KEY WEST HISTORIC SEAPORT
PHASE ONE
KEY WEST, FLORIDA

ADDENDUM NO. 1

February 17, 2015

A-4

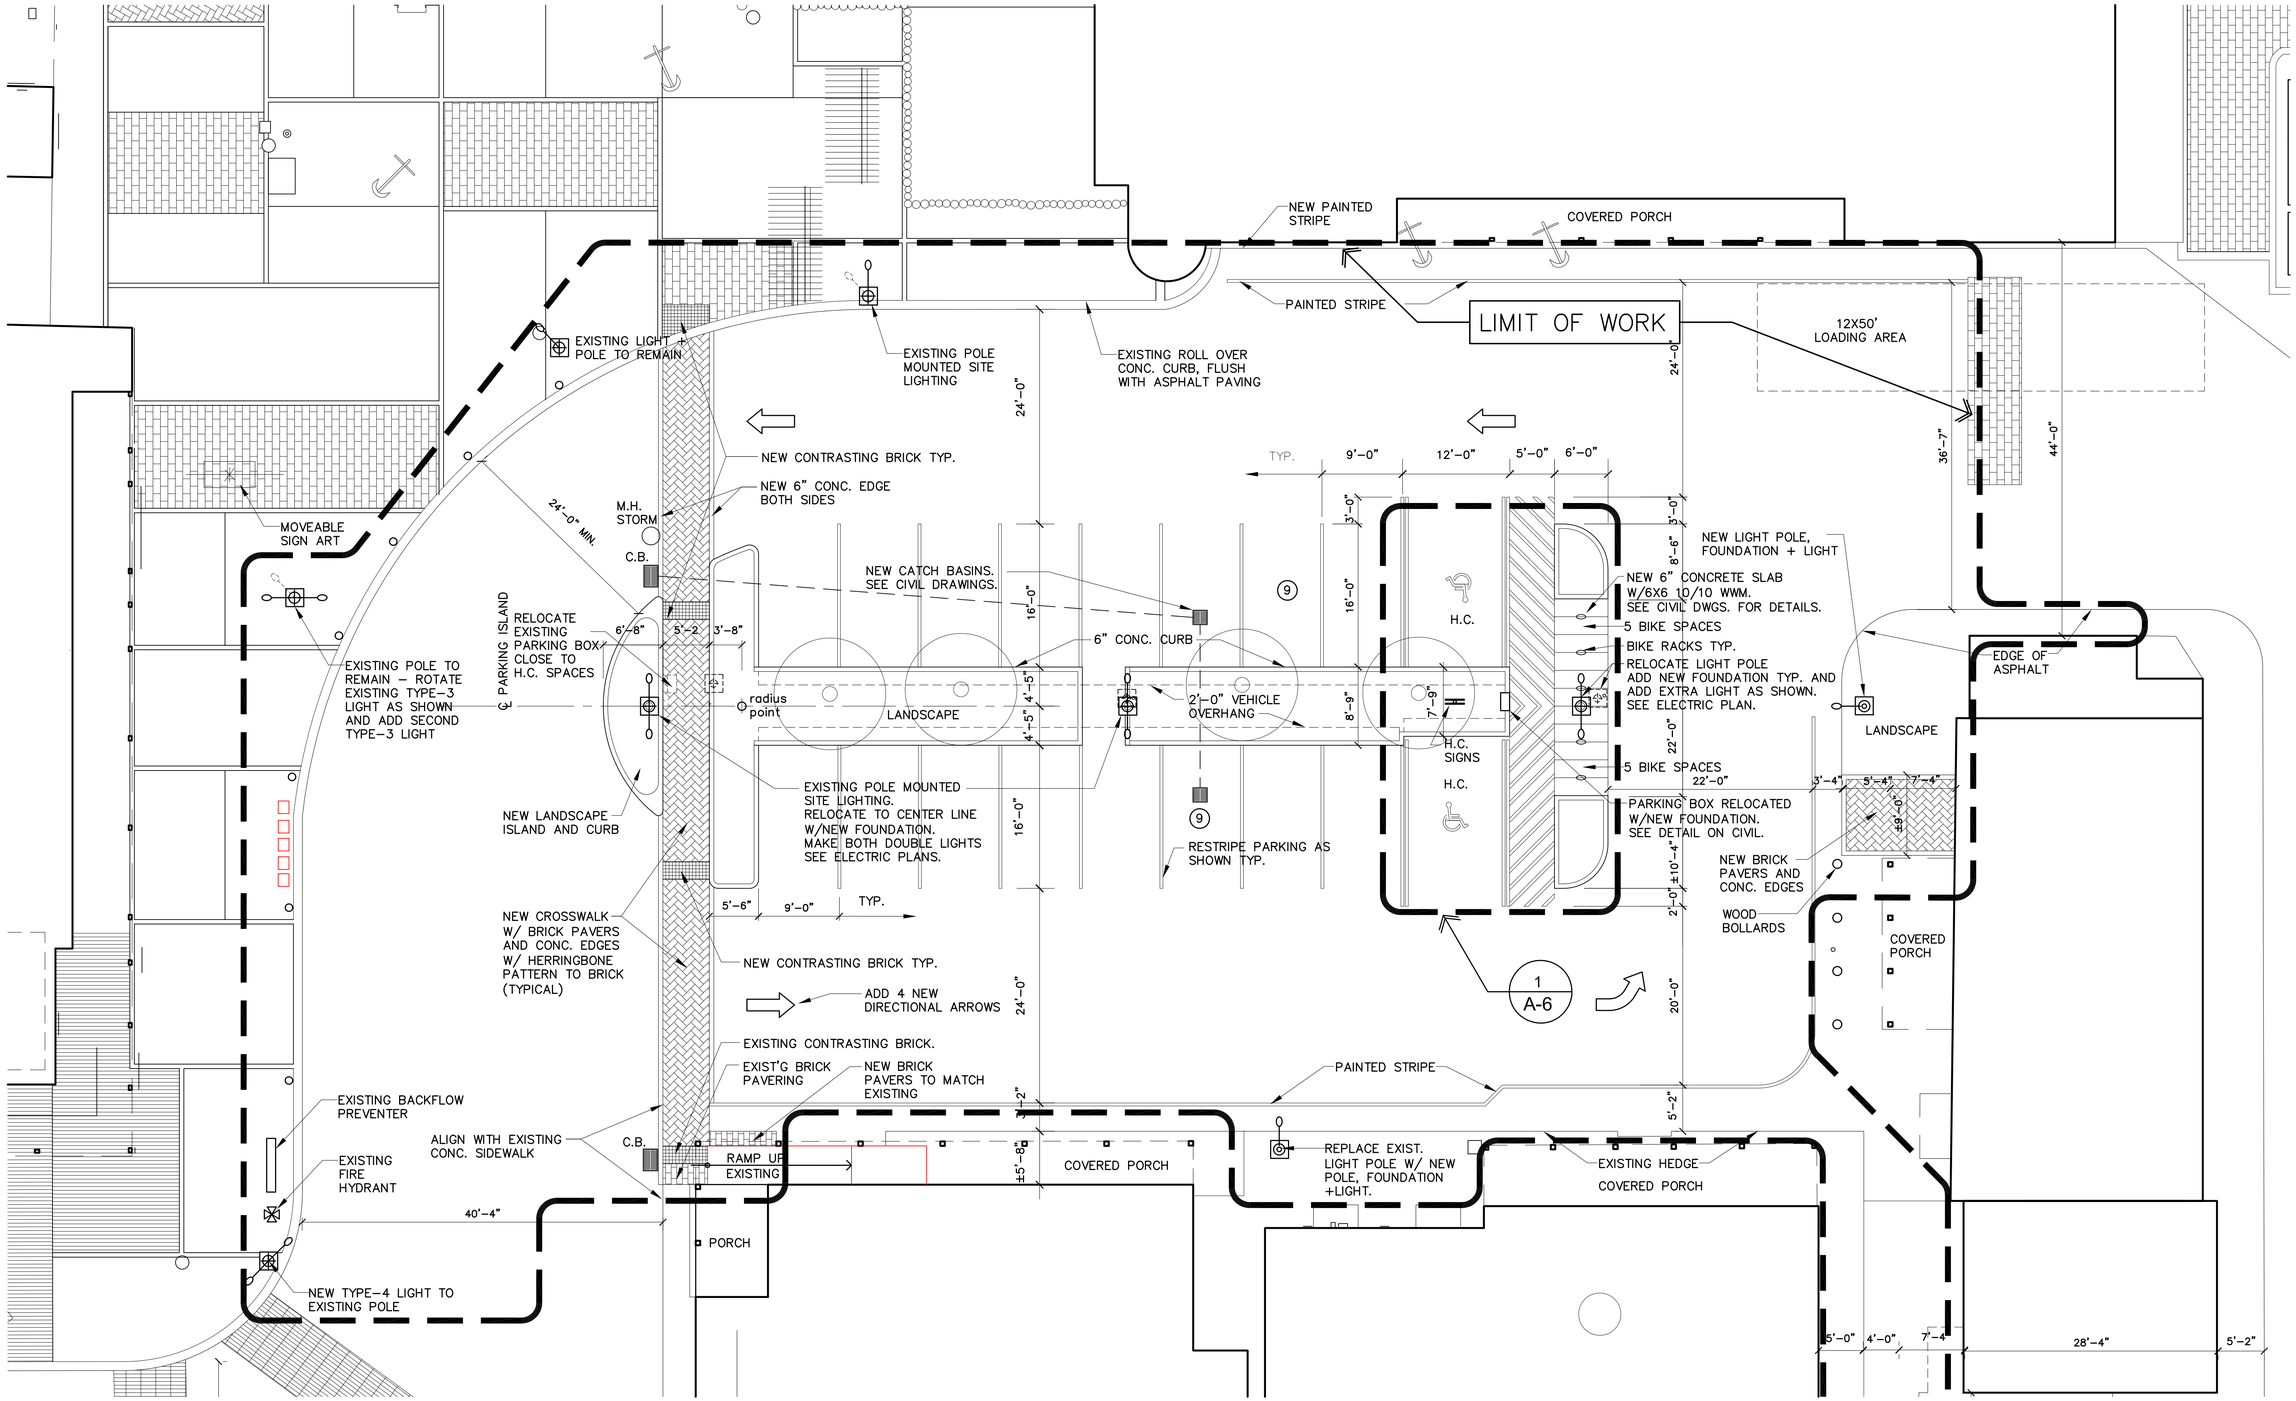
3. Sheet A-4 shows "existing contrasting brick" at the southwest area of work. This contrasting brick does NOT exist. Also, the drawings show this brick running perpendicular to the ramp direction. Please advise.

24. It was discussed to seal coat the existing asphalt once all work is complete. Please provide the extents of seal coating.

Add the contrasting brick to the end of the existing ramp to form a square (approximately 4'x4') of contrasting brick.

Provide price to seal coat the entire parking lot of Area 5 (within the limit of work area shown on revised sheet A-4. Include within this price 4 direction arrows (shown on revised A-4) and restriping all existing striping being covered over by seal coat (including loading zone, fire lanes and other existing striping).

DECK FRAMING PLAN - AREA 1

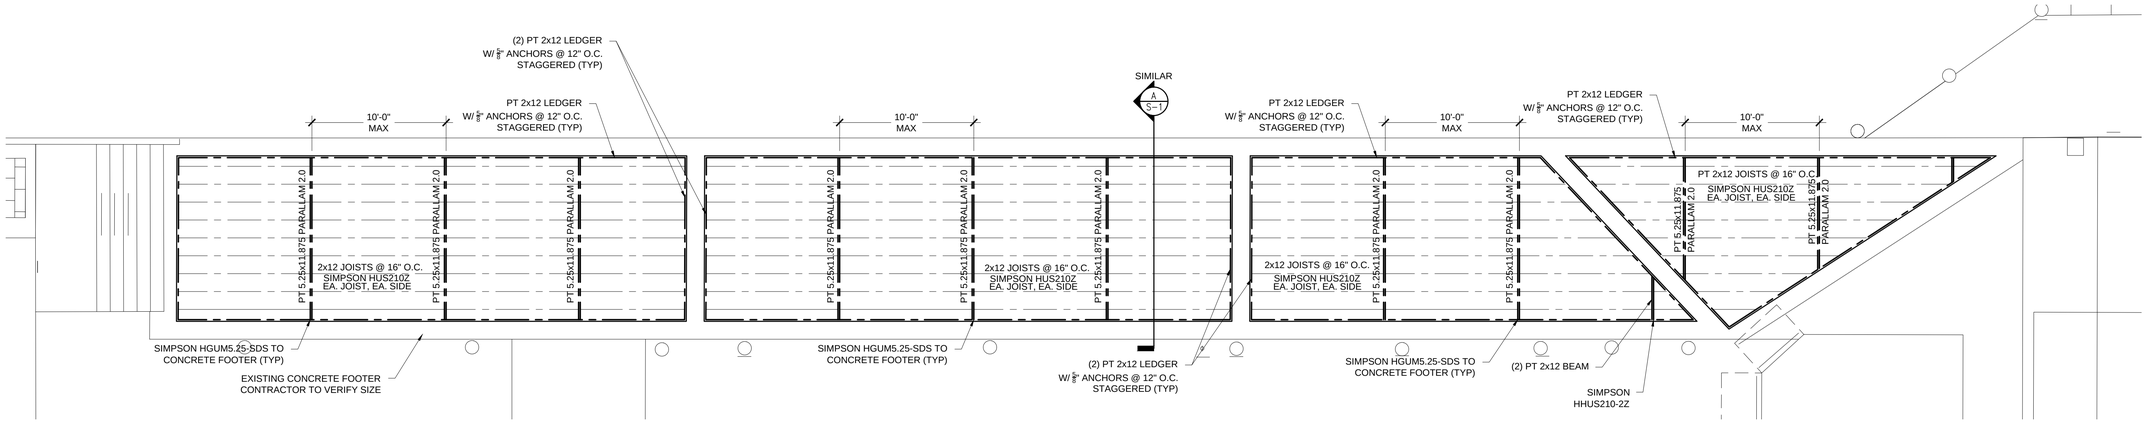
10. The existing wood ramp for the bathrooms at area 3 has concrete footers poured over the existing brick pavers. The Deck Framing Plan at Area 1 on Sheet S-1 shows a new "12x24" grade beam" which will be poured against these pavers. We are concerned the wood ramp / footers will undermine during the installation of this grade beam. Also, due to the 3' thick layer of #57 stone, the trench will be 5' below these footers. Please advise.

13. Please advise if detail A S-1 is to be used at the Deck Framing Plan – Area 1 on sheet S-1. Currently this detail is not indicated in Area 1.

See Revised S-1 for new section cut and shallower trench. Contractor to shore/support adjacent structures and appurtenances as necessary to build to construction documents.

Yes it will be used in Area 1.

DECK FRAMING PLAN - AREA 3

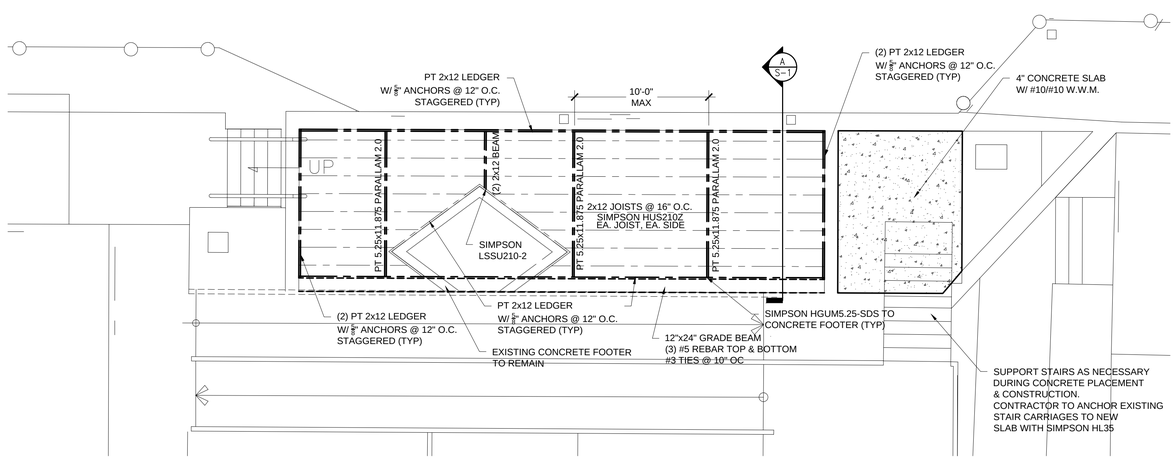
9. Sheet A-2 - Areas #3 shows new Ipe decking under the existing stairs. Sheet S-1 - Area 3 does NOT show any framing in this location. Please advise.

Area revised to show concrete slab in area described above. See Revised S-1

DESCRIPTION: Mounting Detail

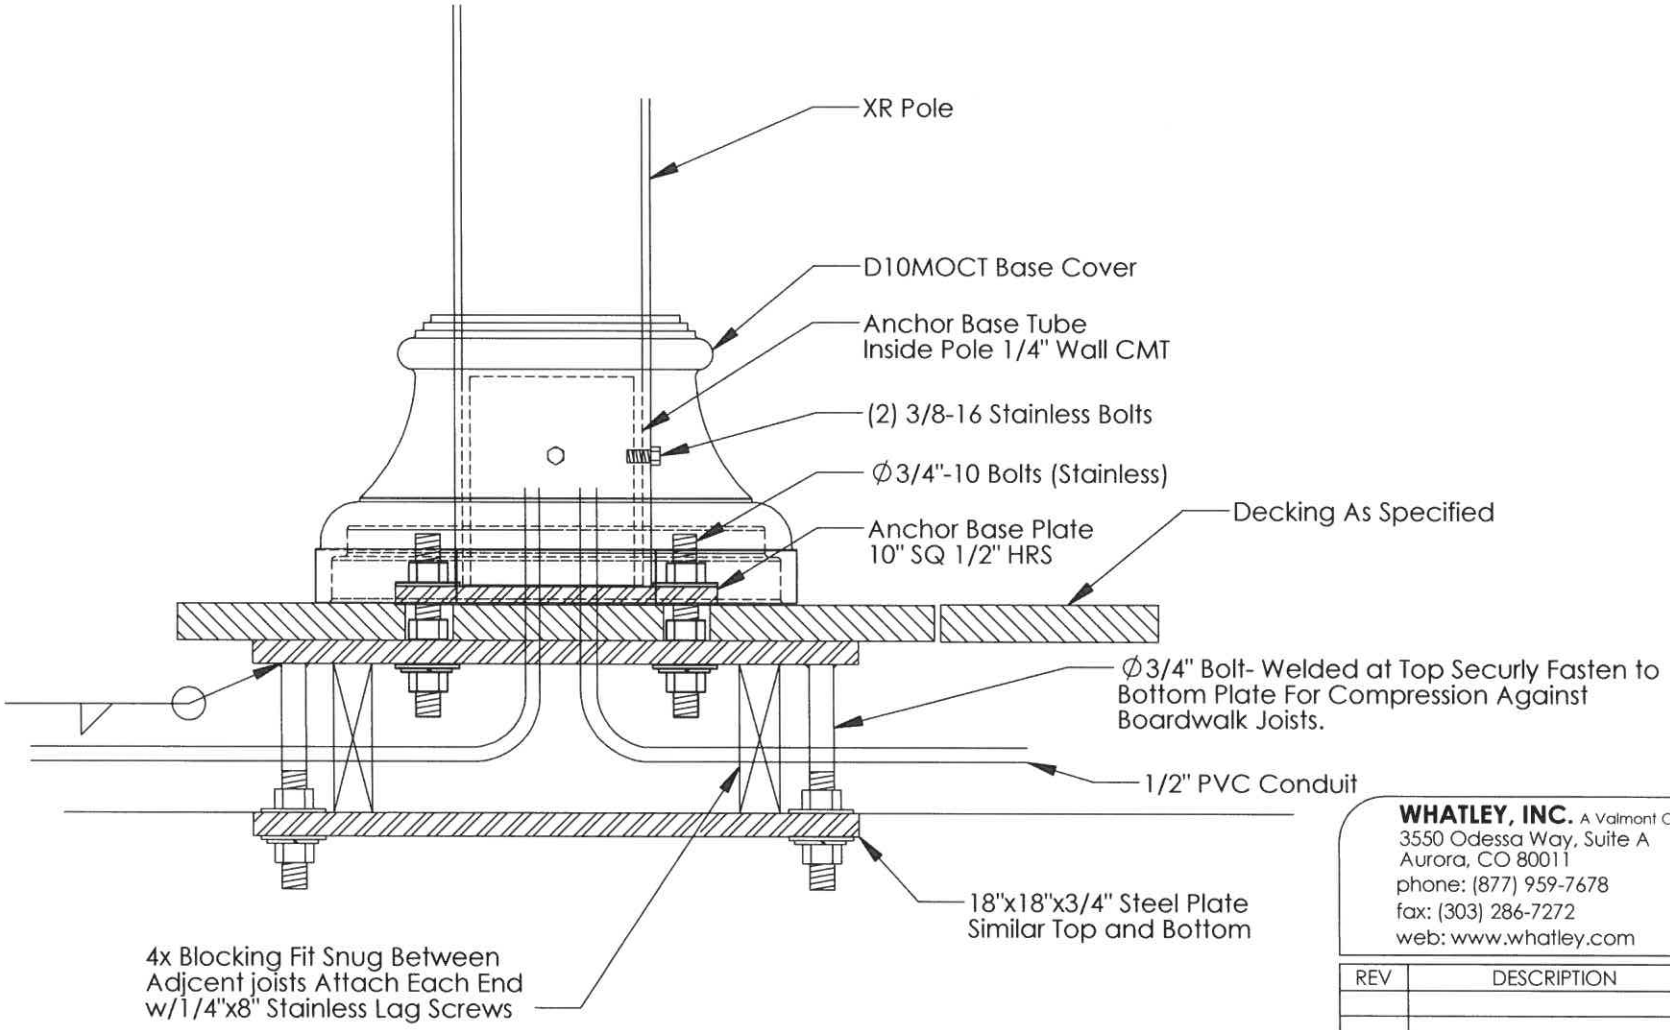
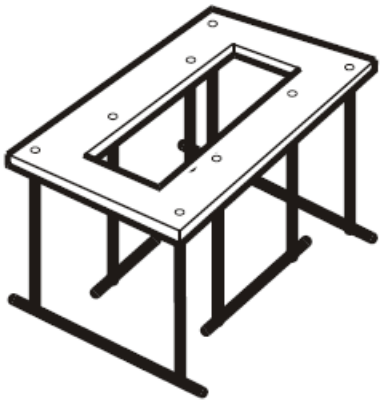
22. Sheet C-3 detail 11 Pay Station Base/Anchor. Please a specification and dimensions, material, manufacture etc. There is not sufficient information in this detail.

The manufacturer is Cale America (www.caleamerica.com, I-877-620-2253). See attached cut sheets of base.

TRIO™ BIKE RACK

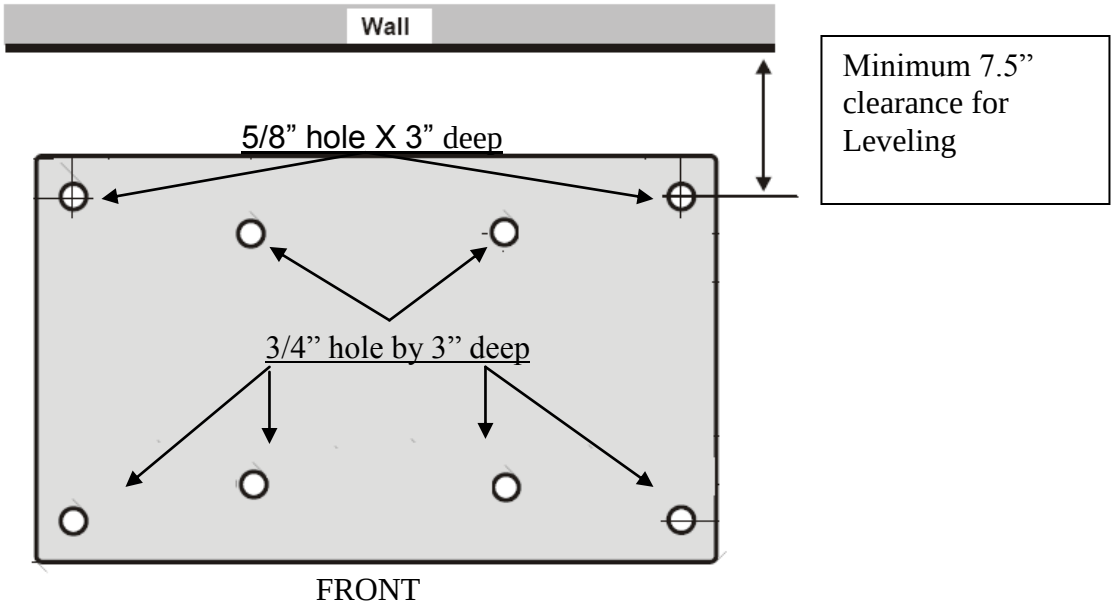
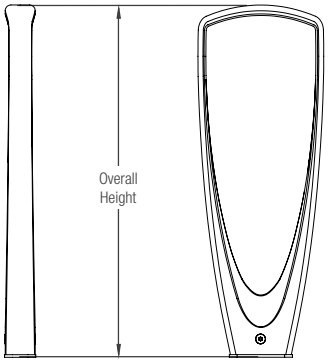
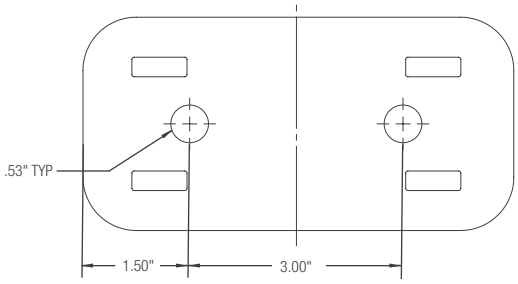
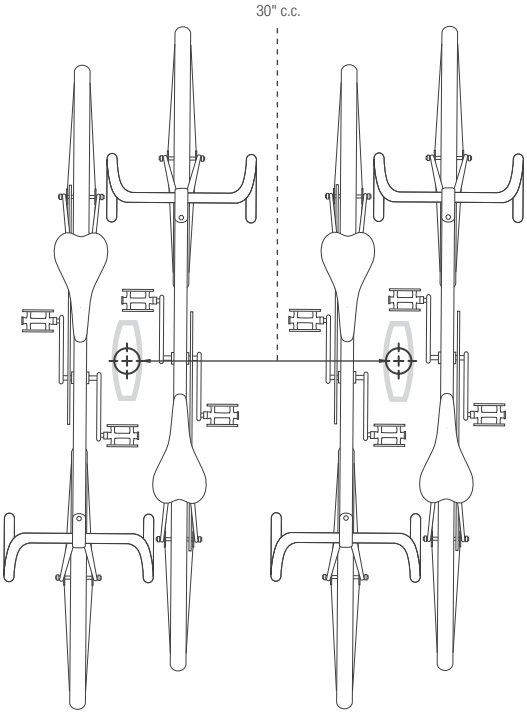
27. **Contractor shall purchase and install 15 bike racks to be located in the field. This will include all anchorage hardware (stainless steel) and a 16"x16"x16" concrete foundation base (if placed individually). Add this cost in the bid form miscellaneous line items.**

Brick rack: SKTRO, AL, PC, SFM

Product: Trio Bike Rack

Body Material: Cast Aluminum

Body Powder Coat Color: Aluminum texture

Dimensions: 12" L x 2.75" D x 33.5" H

Mounting: Surface mounted

See attached photo/ cut sheet of bike rack.
